City of Ramsey
Agenda
Environmental Policy Board (EPB)

Consider Natural Resources Elements of the Waterfront Village Site Plan and Plat (Project No. 23-116); Case of Centra North LLC

WATERFRONT VILLAGE
 RAMSEY, MINNESOTA
PRELIMINARY LANDSCAPE PLAN
 FOR
CENTRA HOMES
 11460 ROBINSON DRIVE, COON RAPIDS, MN

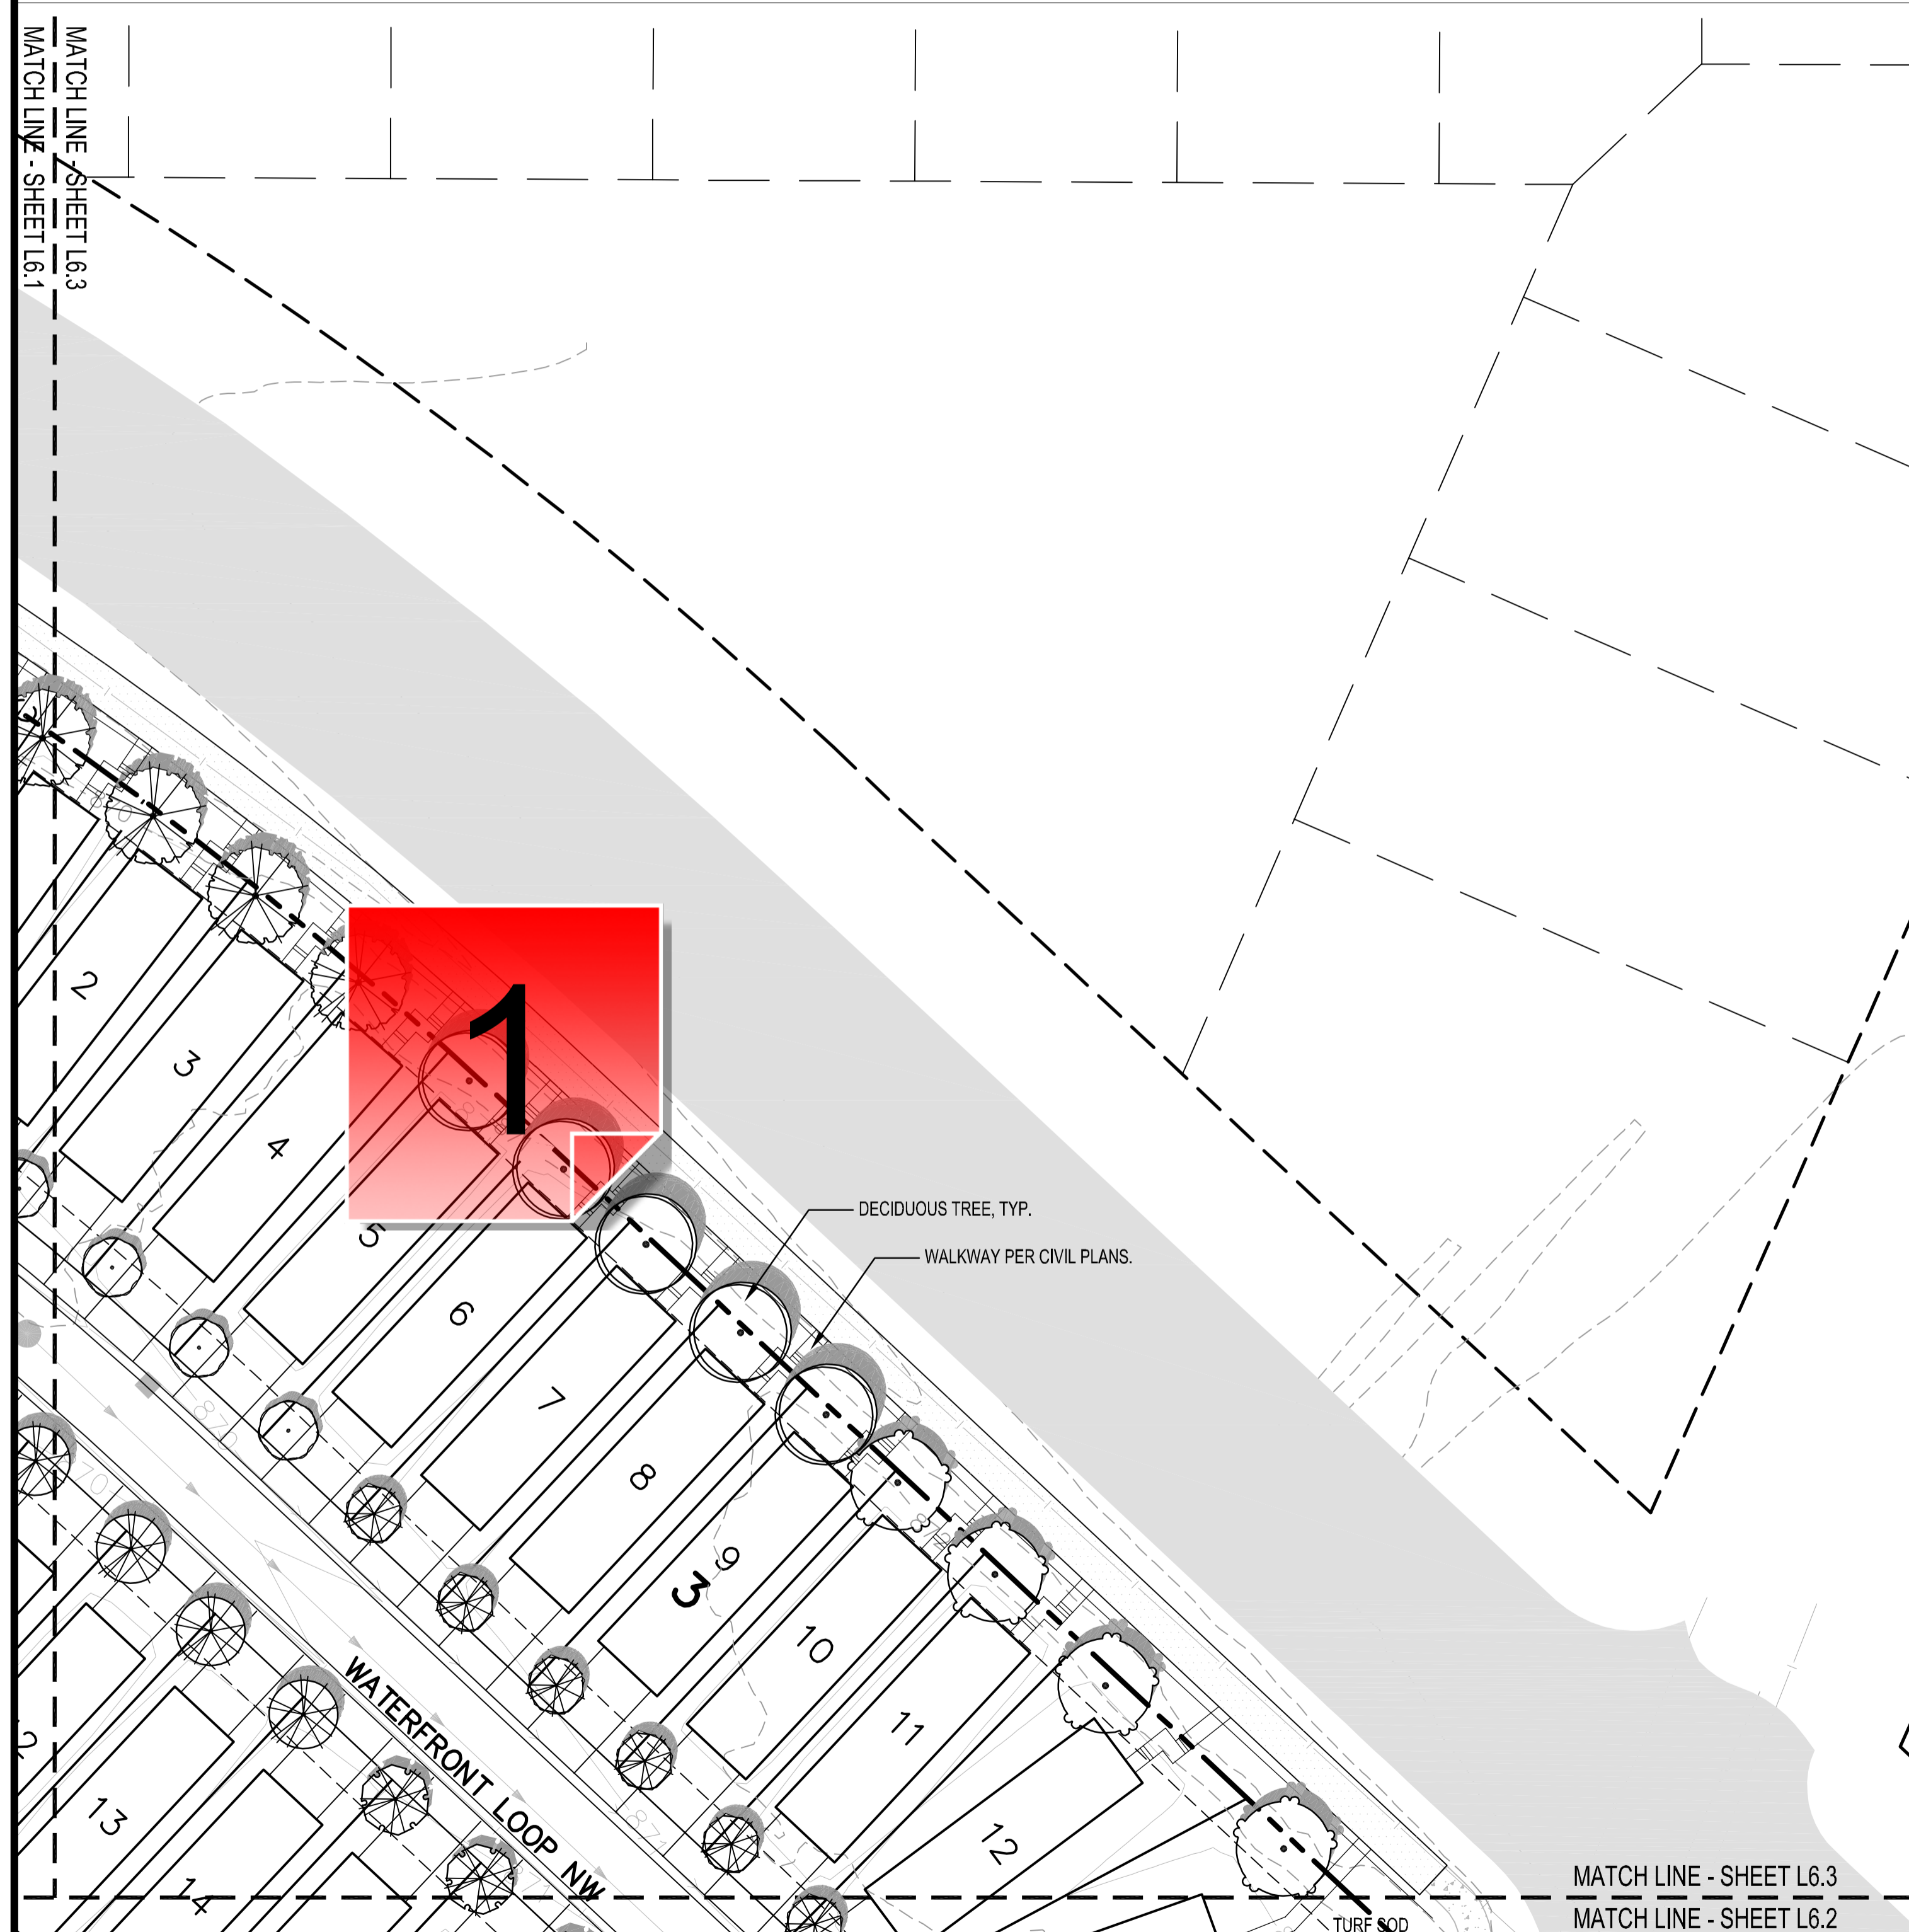
Clarify the need for stairs and jogs in each of the sidewalks that connect to Bunker Lake Blvd.

When these trees are installed in the rear of these lots, make sure there is sufficient growing space so that at maturity, there is no conflict between trees and structures.

LANDSCAPE LAYOUT EAST:

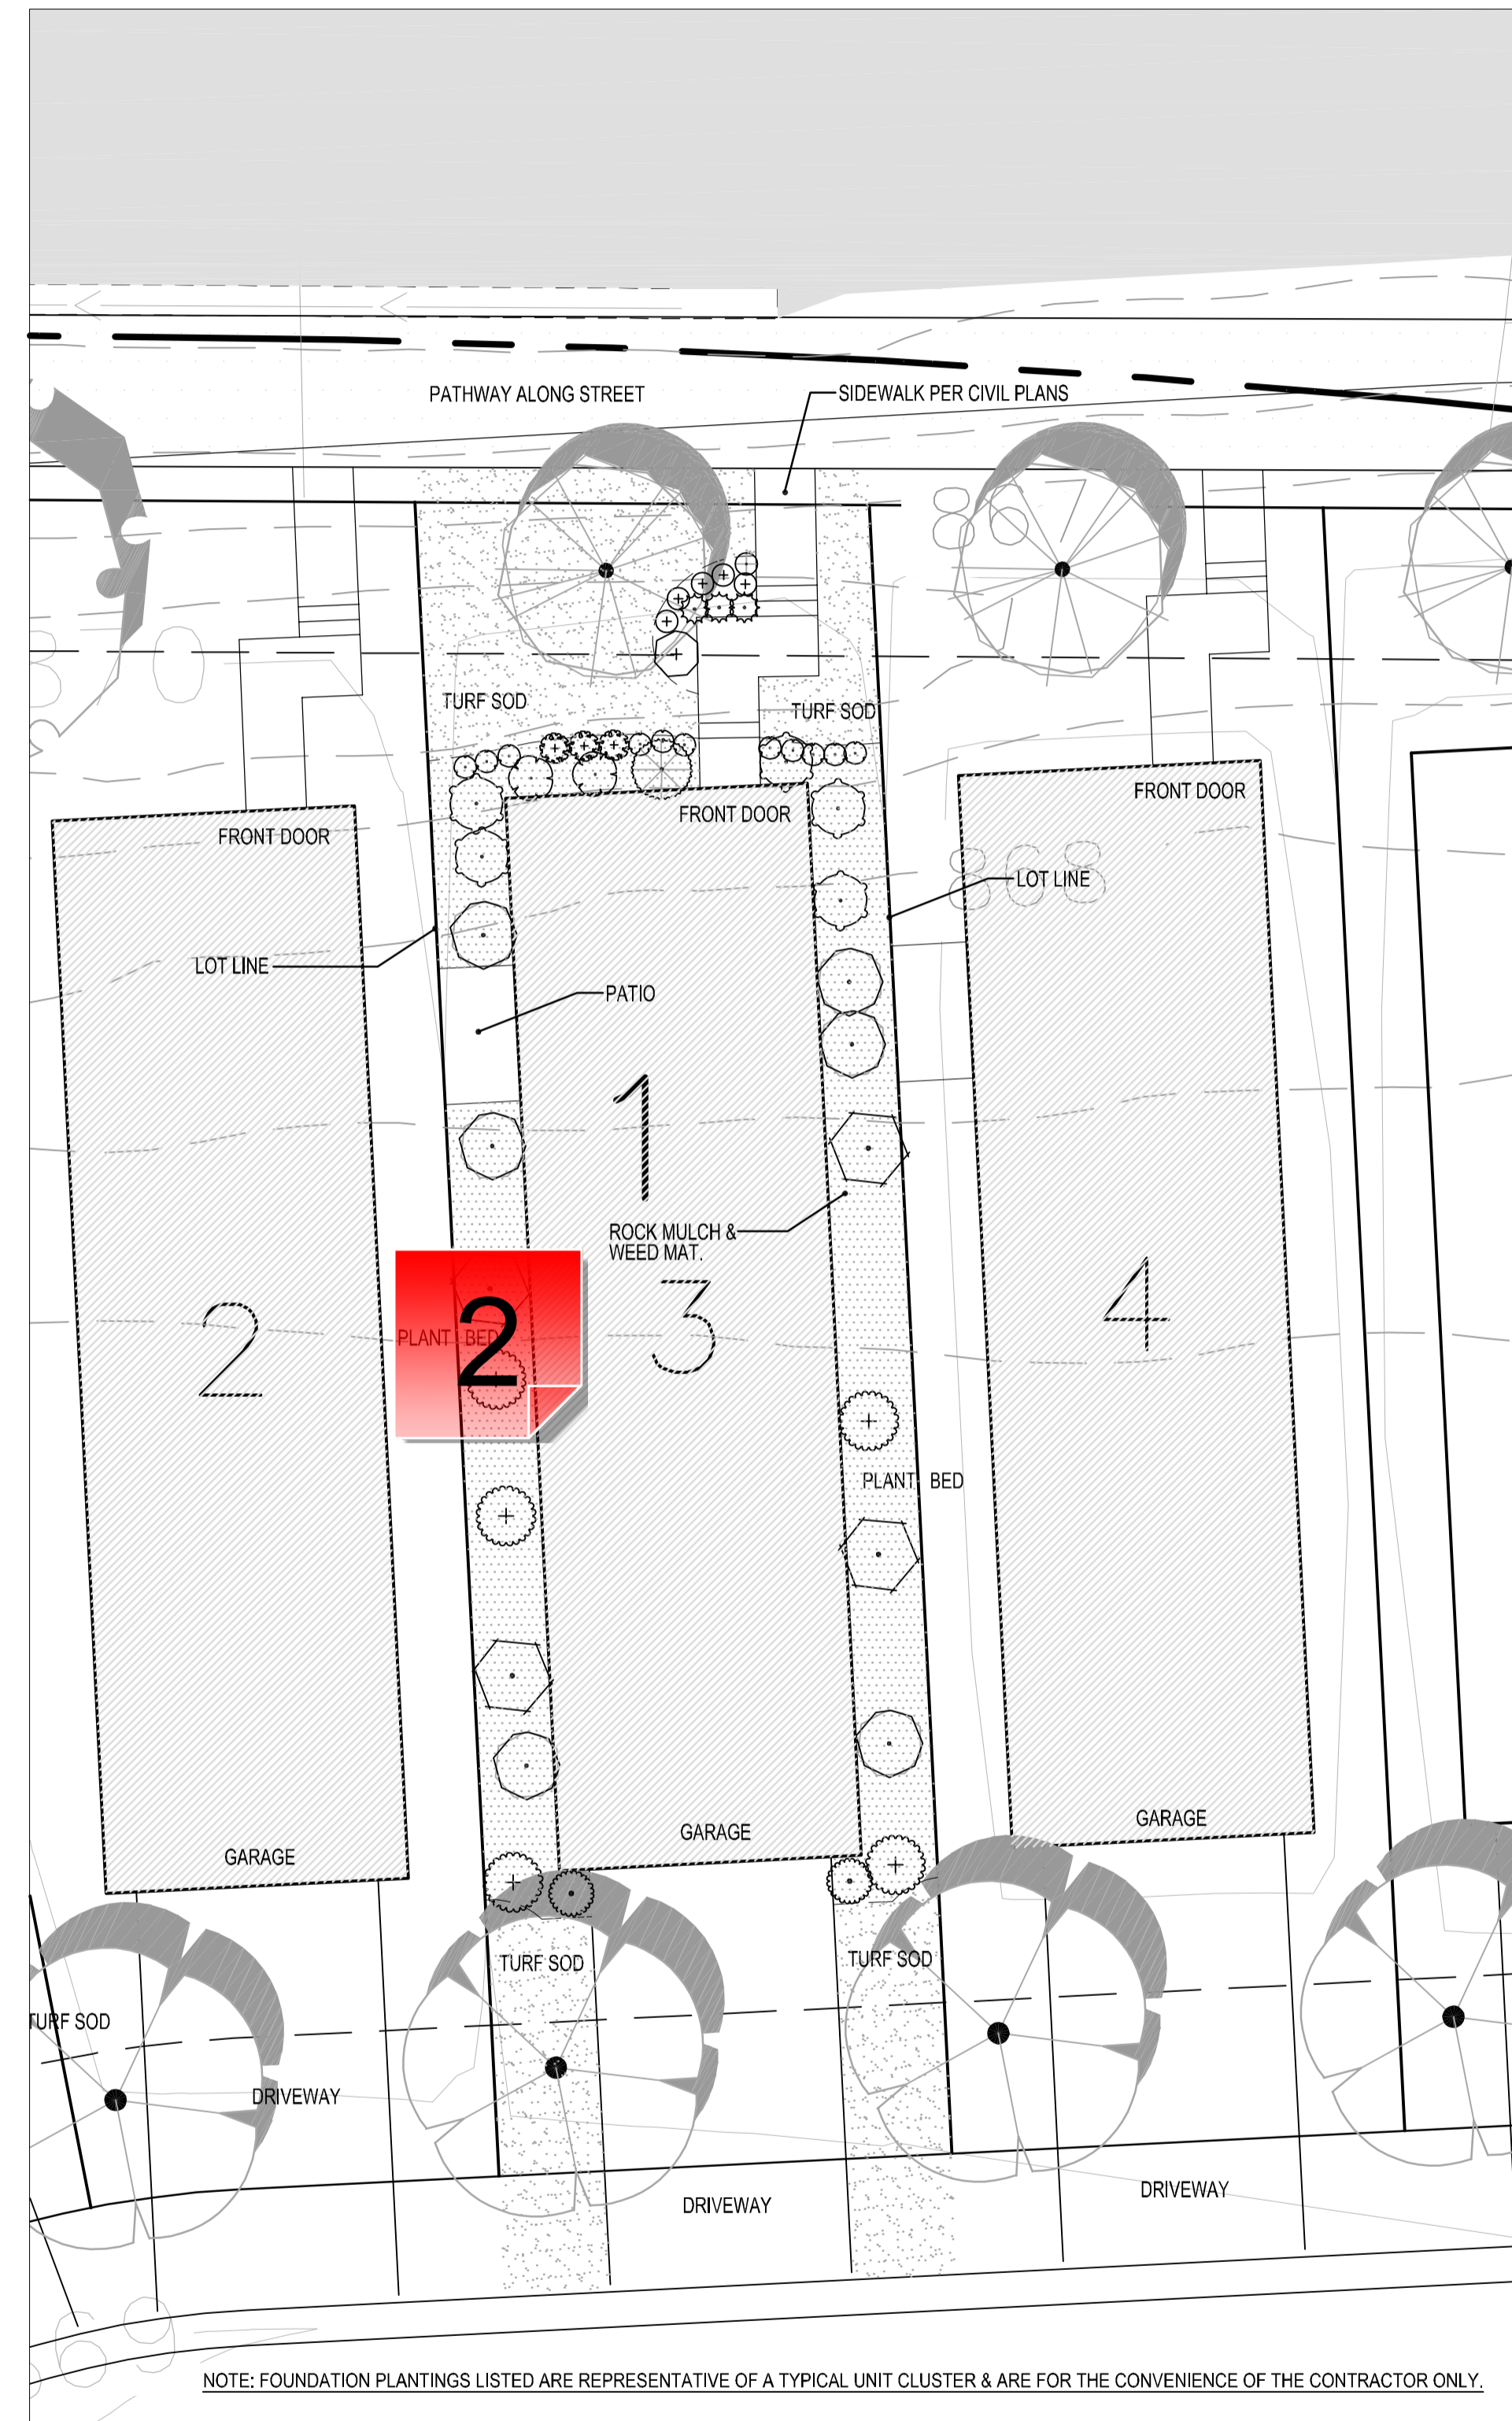
As noted on other plan sheets, clarify the need for stairs and jogs on each of the sidewalks that connect to Bunker Lake Blvd.

Another item regarding the landscaping plans is the proposal to install plant beds, rock mulch, and weed mats in between each house. The Cottages at the COR had proposed commercial turf sod in between houses, but it was ultimately built with rock beds and a few shrubs instead. Please provide clarity on the landscaping in between units.

Both species substitutions and plan changes require approval of city prior to installation. Update this note accordingly.

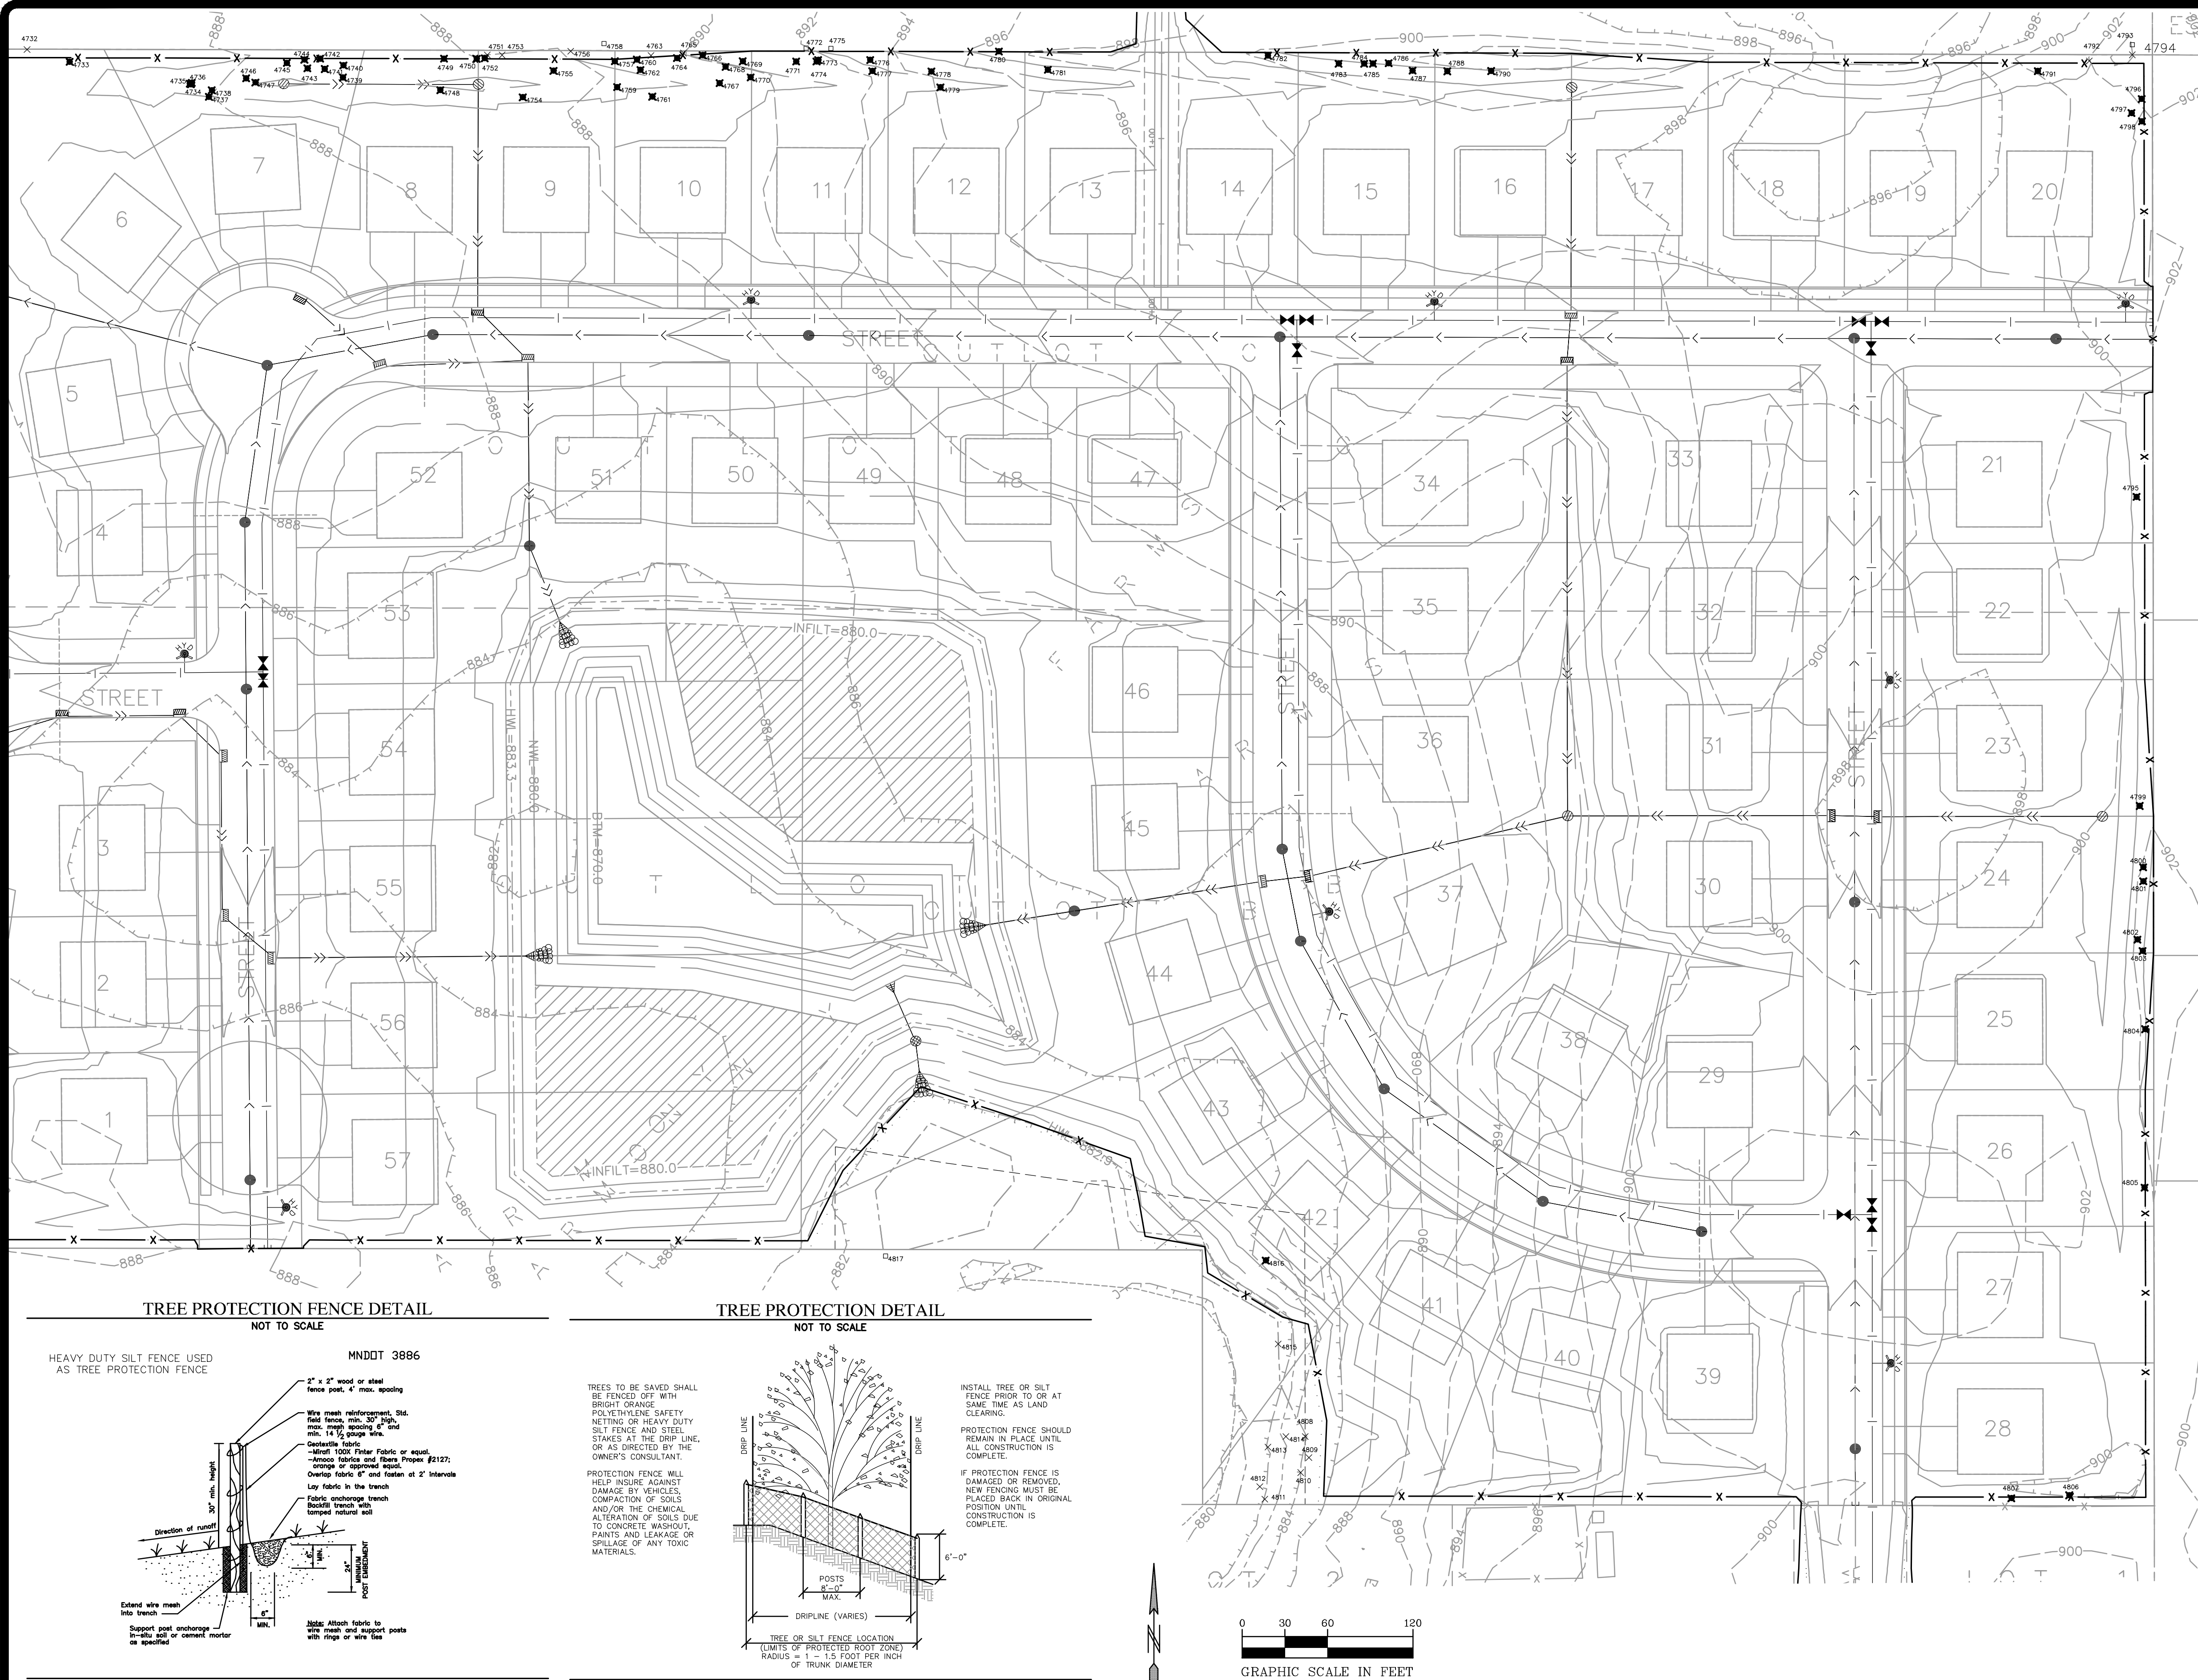
The Planting Schedule indicates some species at 3" and others at 2.5". The calculation shows all trees at 2.5". Please either update the Planting Schedule with correct size or update the calculation with correct # of proposed inches.
